REVISION 001 TO A INVITATION TO TENDER

Title - Sujet : Mechanical Systems Upgrade, Battle of the Restigouche National Historic Site		
Solicitation No. - N° de l'invitation : 5P468-21-0158/A	Date : 08 December 2021	
Amendment No. - N° de modification : 001		
Client Reference No. - N° de référence du client : 1408		
GETS Reference No. N° de référence de SEAG : PW-21-00975348		
Solicitation Closes - L'invitation prend fin : At - à : 14 :00 On - le : 16 December 2021		Time Zone - Fuseau horaire EST
F.O.B. - F.A.B. : Plant - Usine : <input type="checkbox"/> Destination : <input checked="" type="checkbox"/> Other - Autre : <input type="checkbox"/>		
Address Enquiries to - Adresser toutes demande de renseignements à : Jaime Creaser		
Telephone No. - N° de telephone : 902-266-8592	Fax No. -N° de télécopieur : 1-877-558-2349	Email Address – Courriel : Jaime.Creaser@pc.gc.ca
Destination of Goods, Services, and Construction - Destination des biens, services, et construction : See Herein

File : Mechanical Systems Upgrade
APC Project : 1408-4

Addendum No : ME-01

PROTECTION-INCENDIE SOUS-SOL DÉMOLITION / FIRE PROTECTION - UNDERGROUND FLR - DEMOLITION

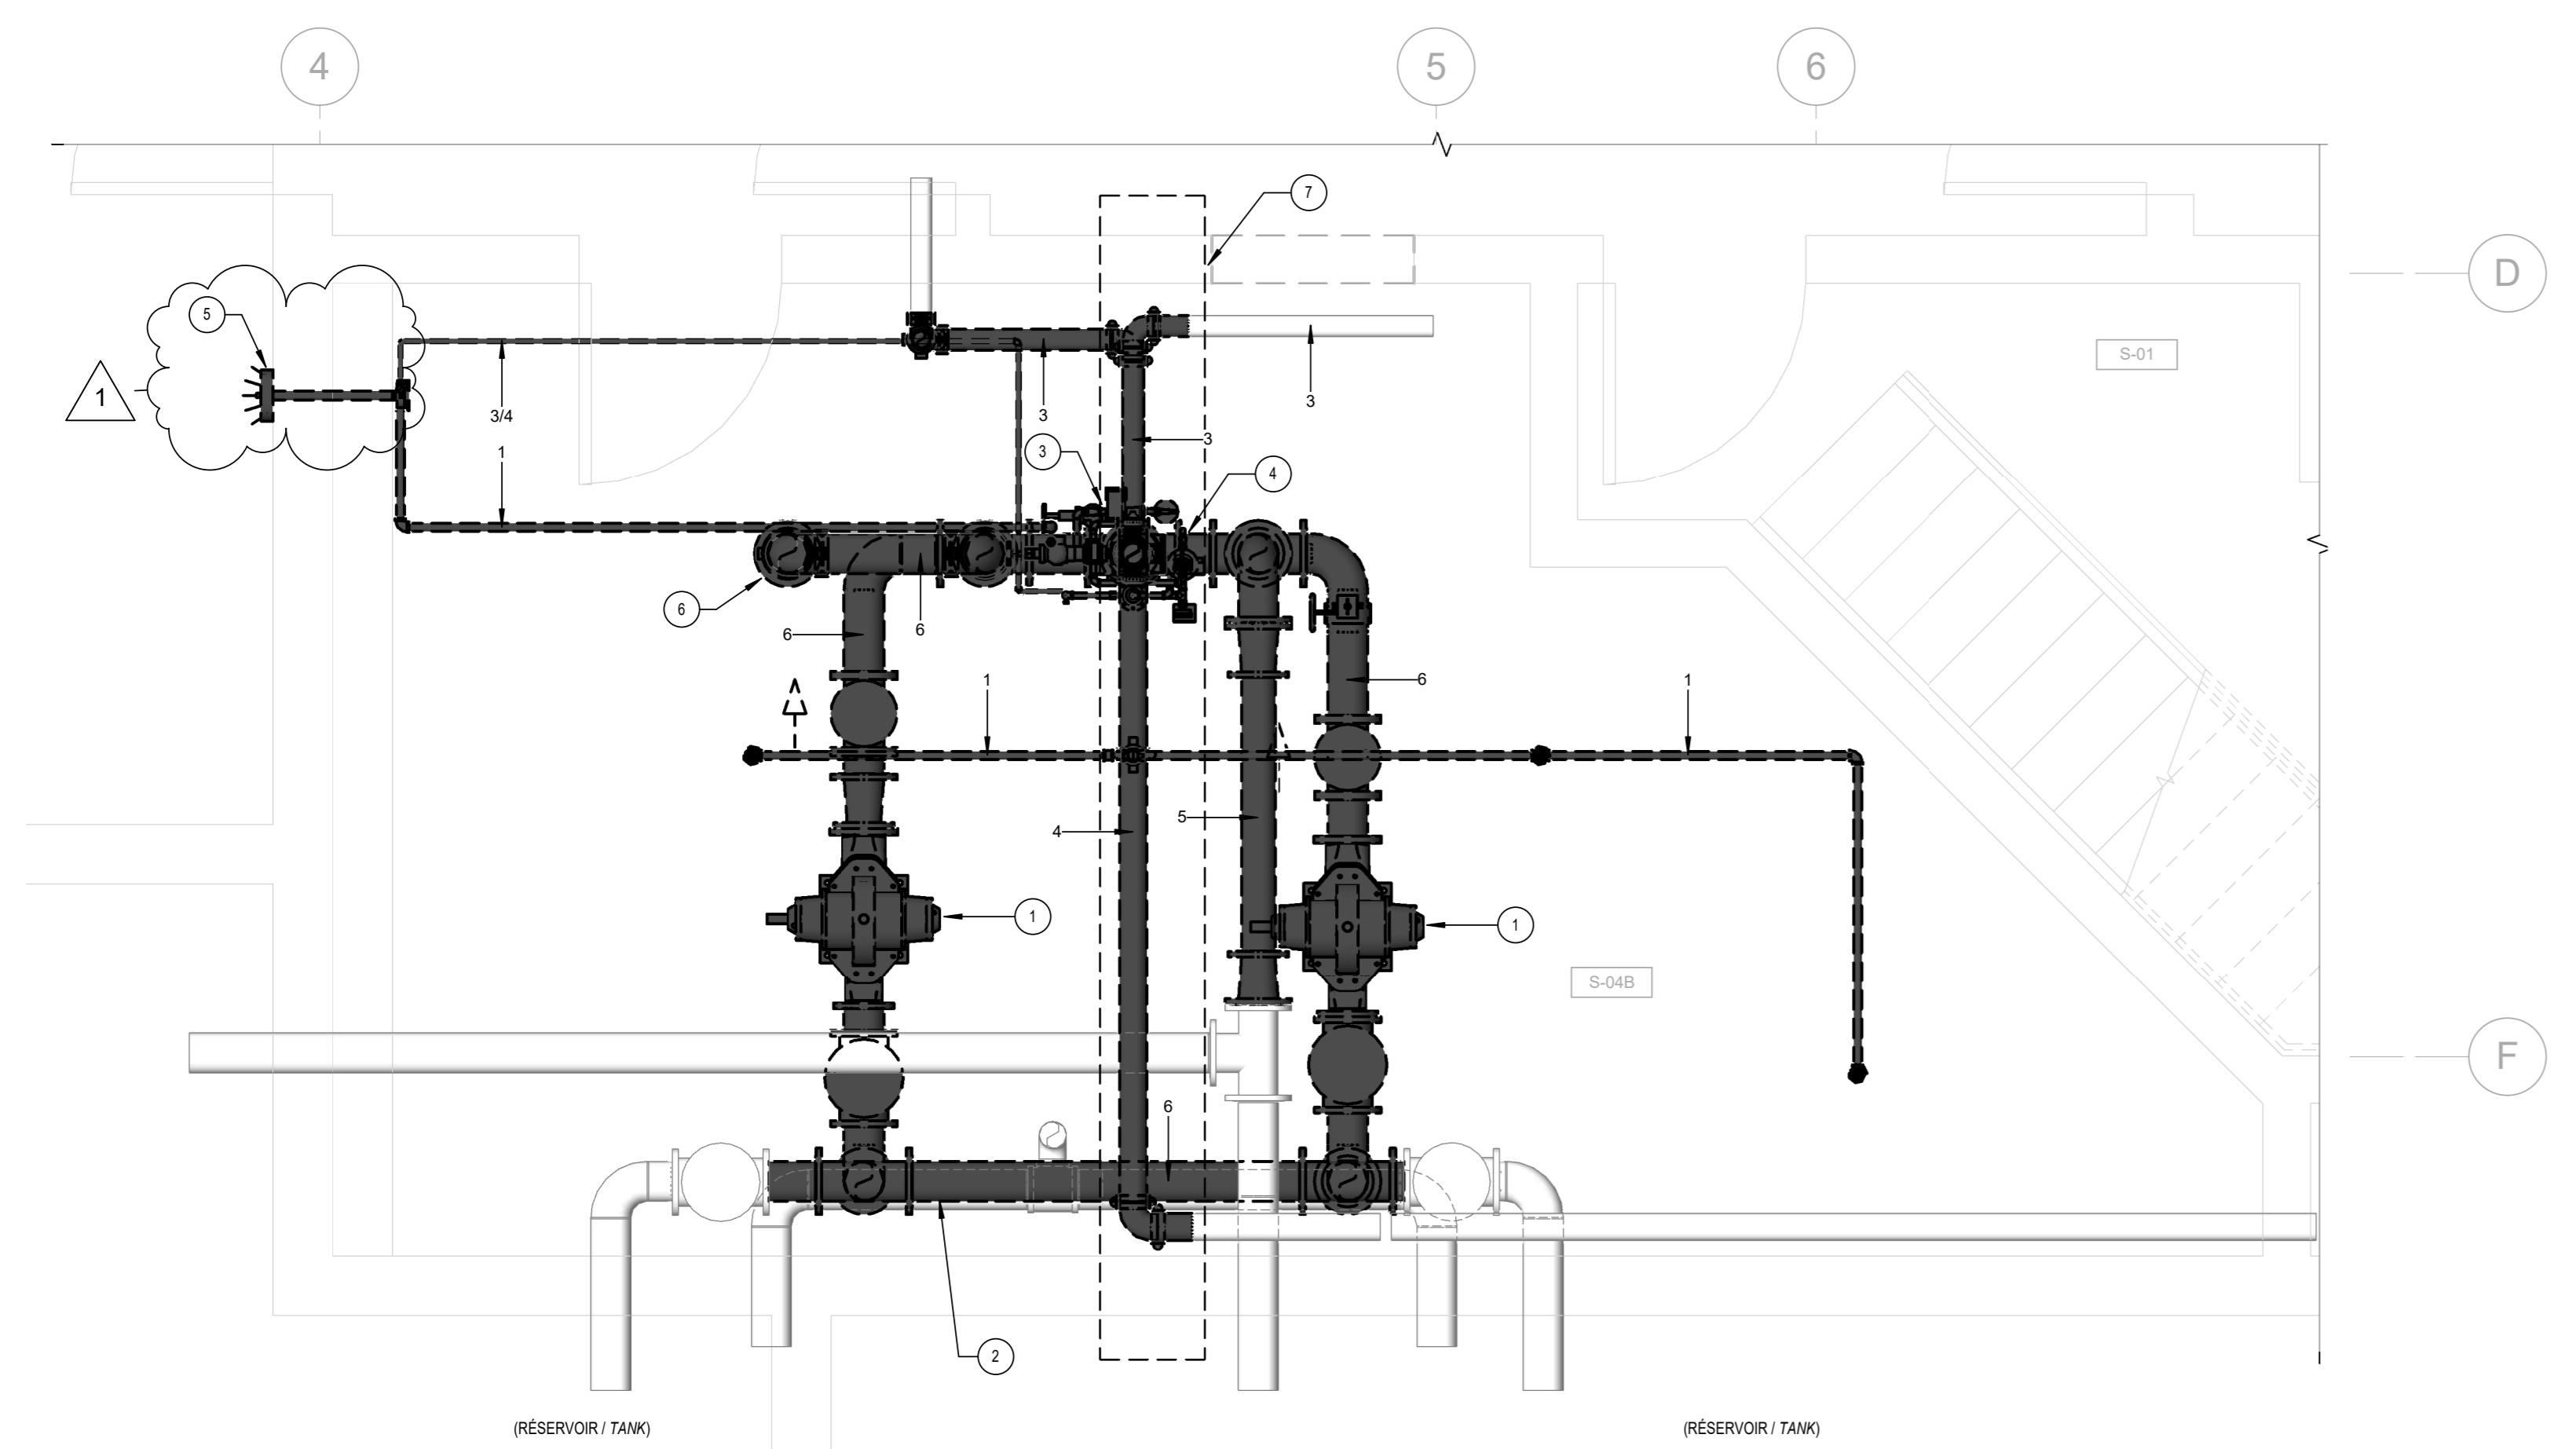
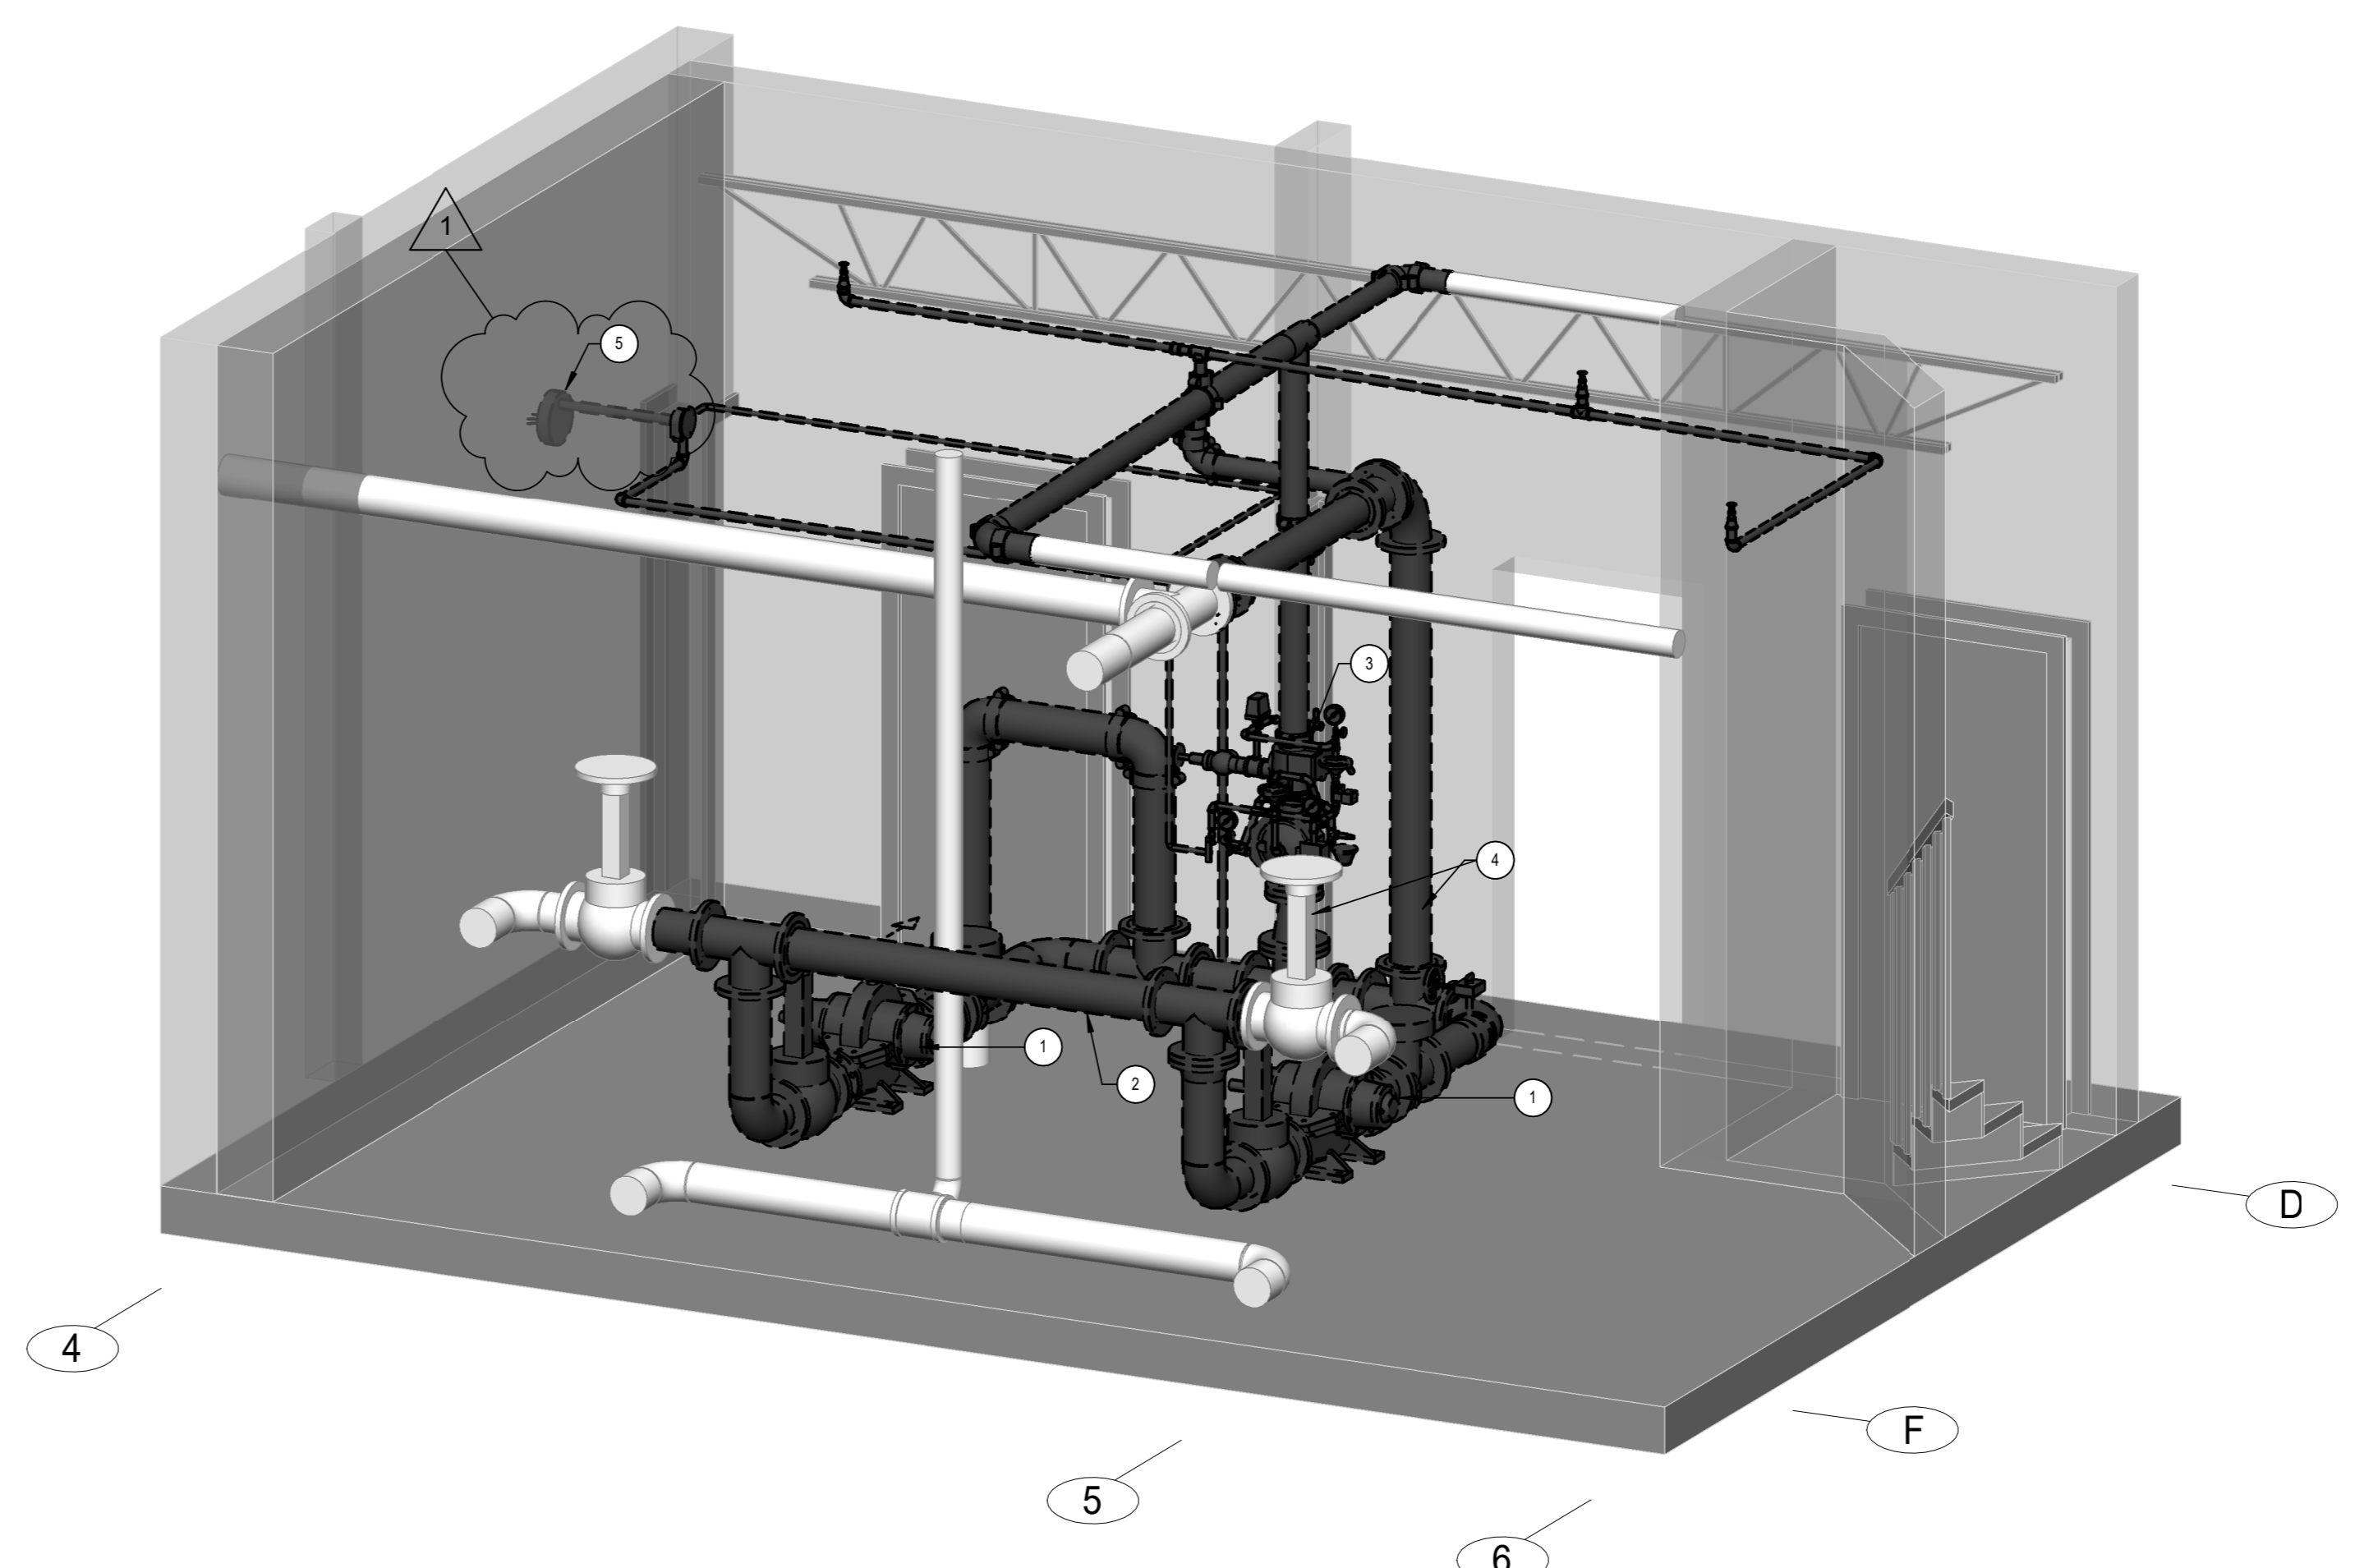
2.1.1 Plan M301 - FIRE PROTECTION - UNDERGROUND FLR – DEMOLITION

- .1 Keynote #5 is modified as follows: *WATER MOTOR GONG TO DEMOLISH AND EVACUATE FROM THE SITE.*

.2 Plan M301 is reissued with revision 1.

- 4 DEUX POMPES D'APPOINT À DÉMOLIR ET DISPOSER. / TWO JOCKEY PUMPS TO DEMOLISH AND EVACUATE FROM THE SITE.
 - 5 CLOCHE HYDRAULIQUE À DÉMOLIR ET DISPOSER. / WATER MOTOR GONG TO DEMOLISH AND EVACUATE FROM THE SITE.
